AEROPRAKT SERVICE BULLETIN

No. SB A32-05

REINFORCEMENT OF THE FRAME No.10 OF A32 AND A32L AIRCRAFT

Model: A32, A32L

Fig. 8.

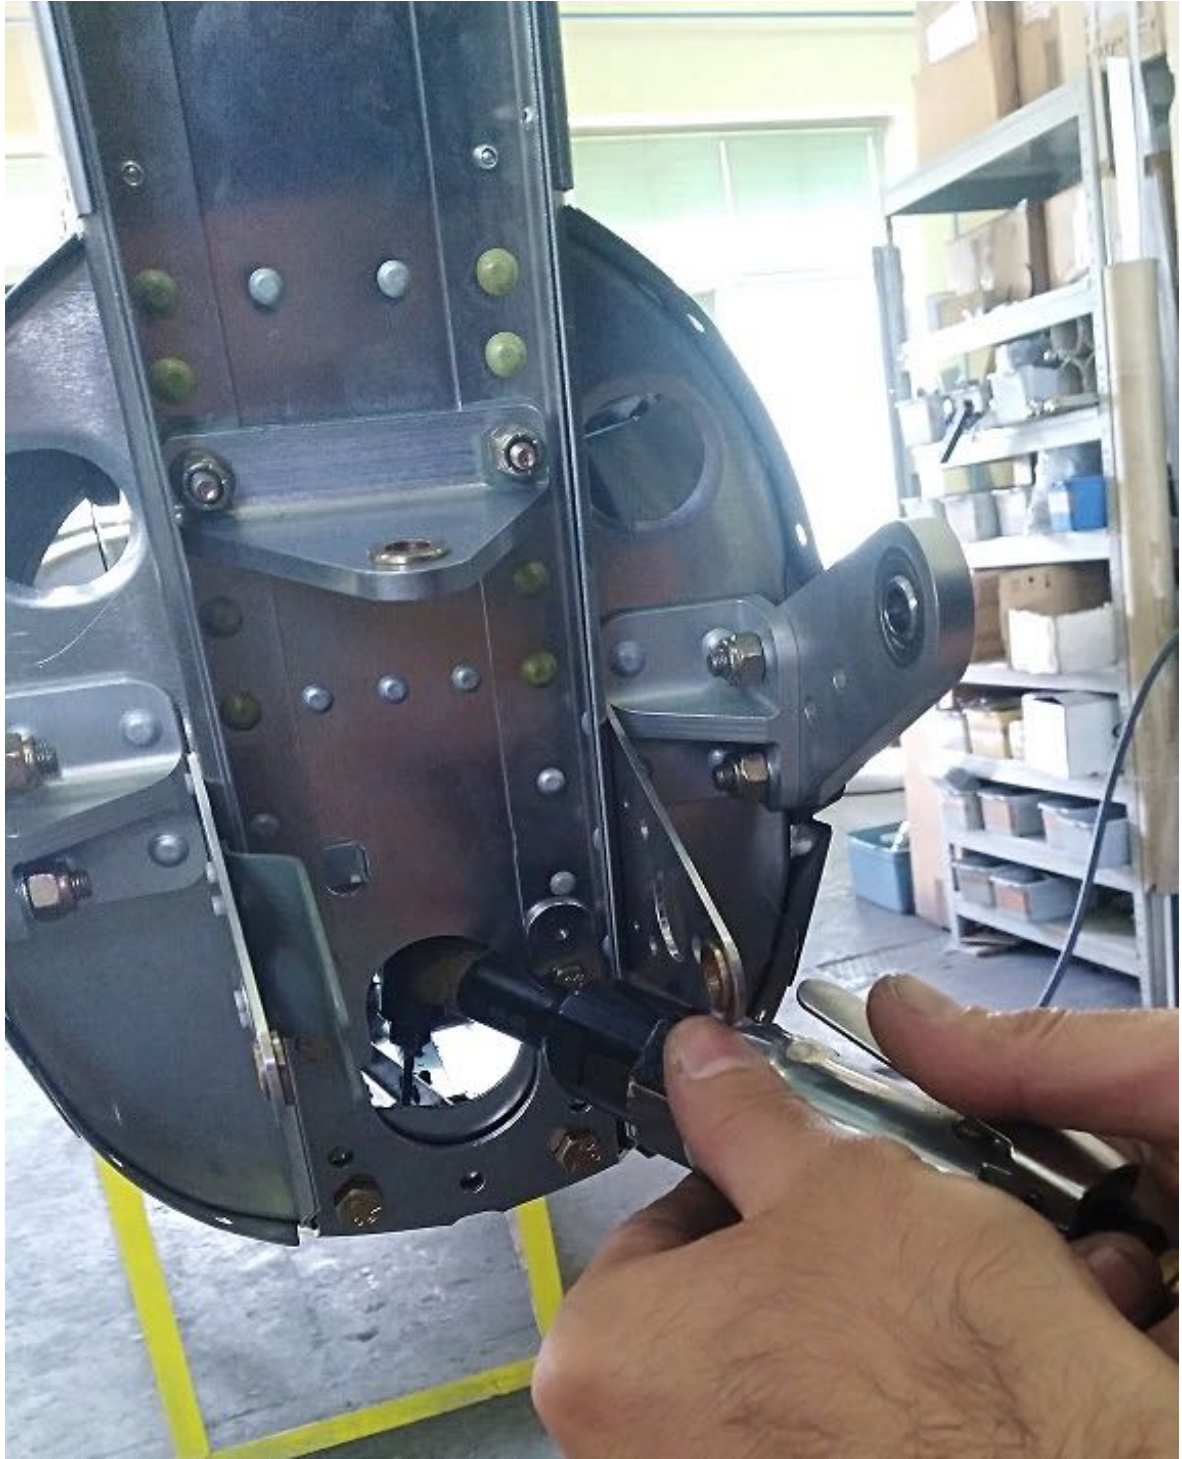
3.8) Install the reinforcing doubler with bolts as shown below, use a 90° drill to mark position of holes in the flanges of the reinforcing doubler through the holes in the frame No. 10 (Fig. 8).

Fig. 10.

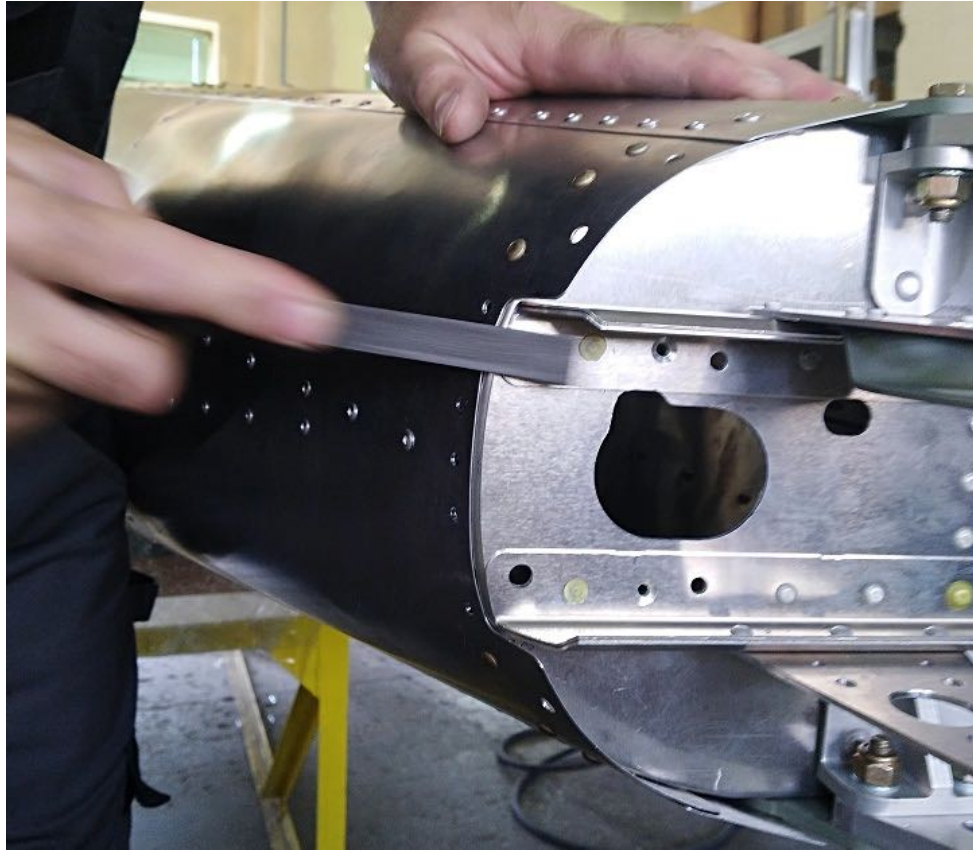
3.10) Round the sharp edge of the fin spar flange to ensure a better fit of the doubler (Fig. 10).

Fig. 12

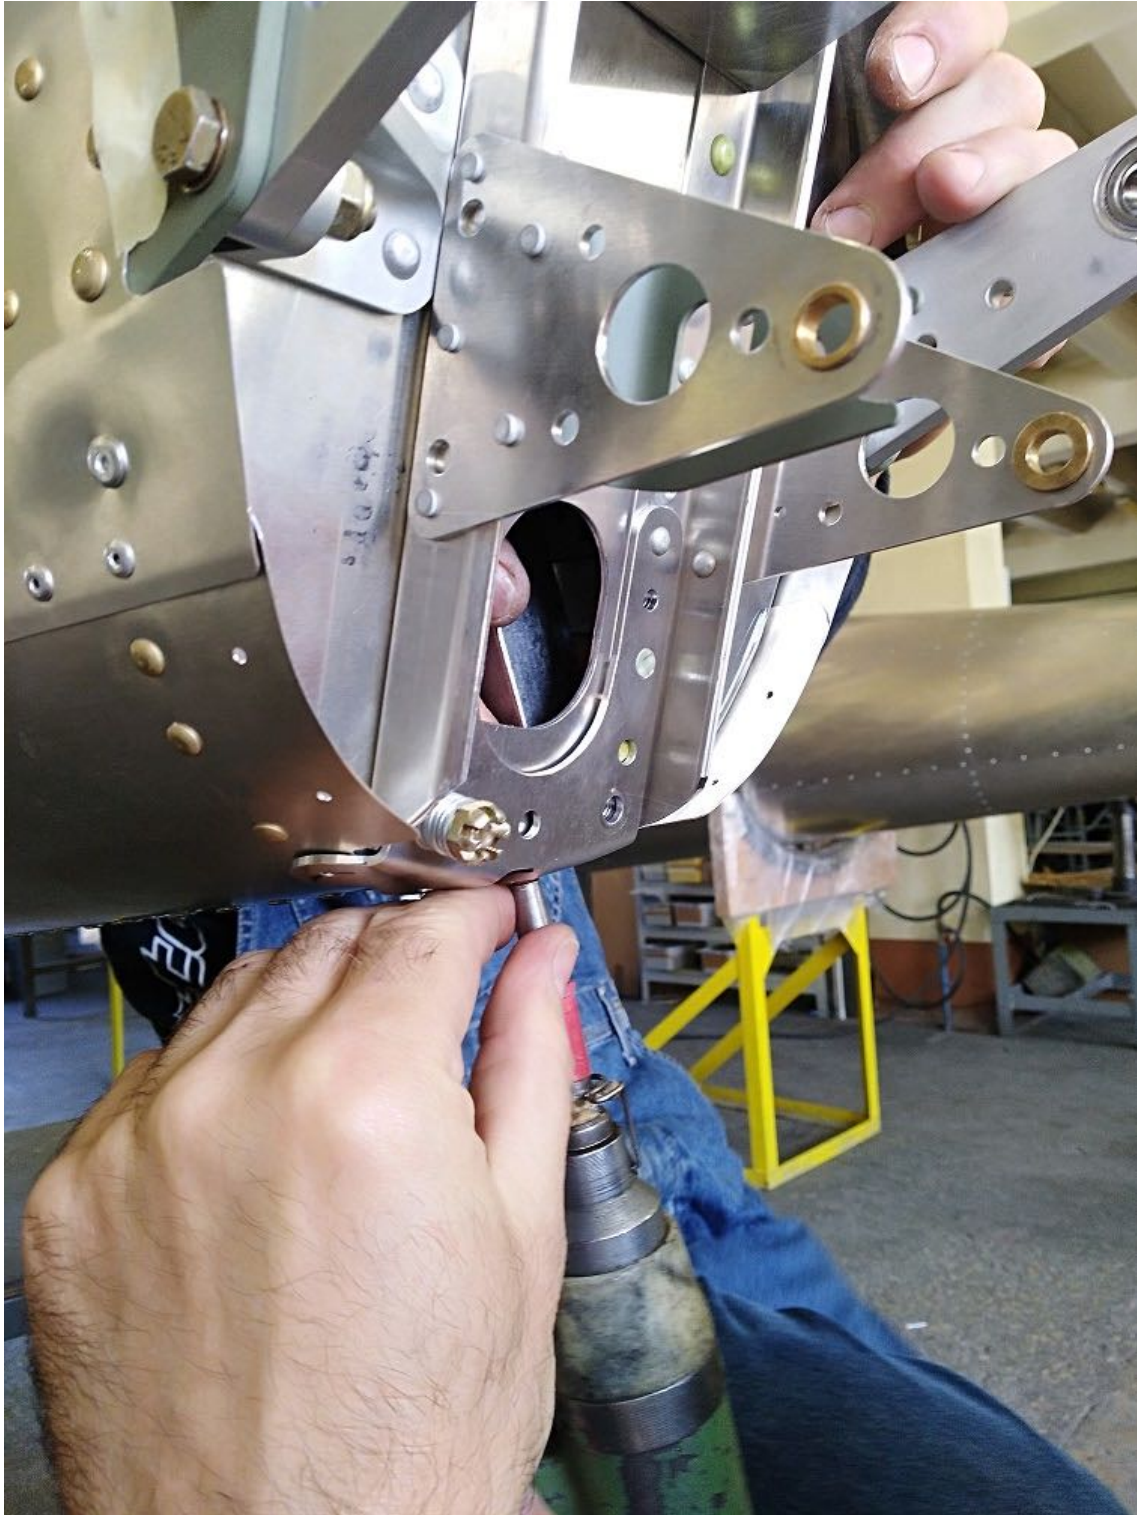
3.12) Install the rivets on the flanges of the doubler (Fig. 12).

Cherry Max rivets P/N CR3213-4-3

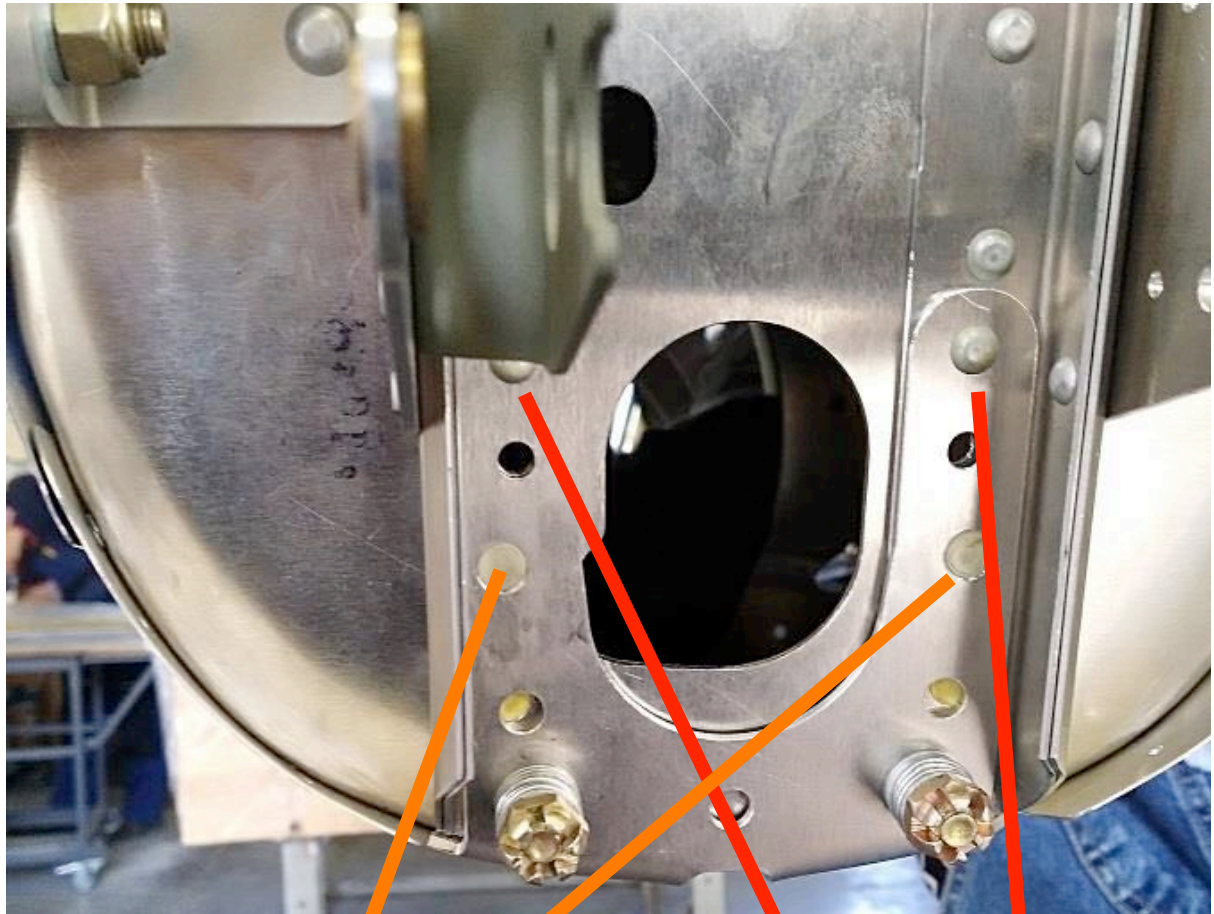
- 1) **Instead of solid rivets use Cherry Max rivets P/N CR3213-4-3 at the location shown in the picture below.**
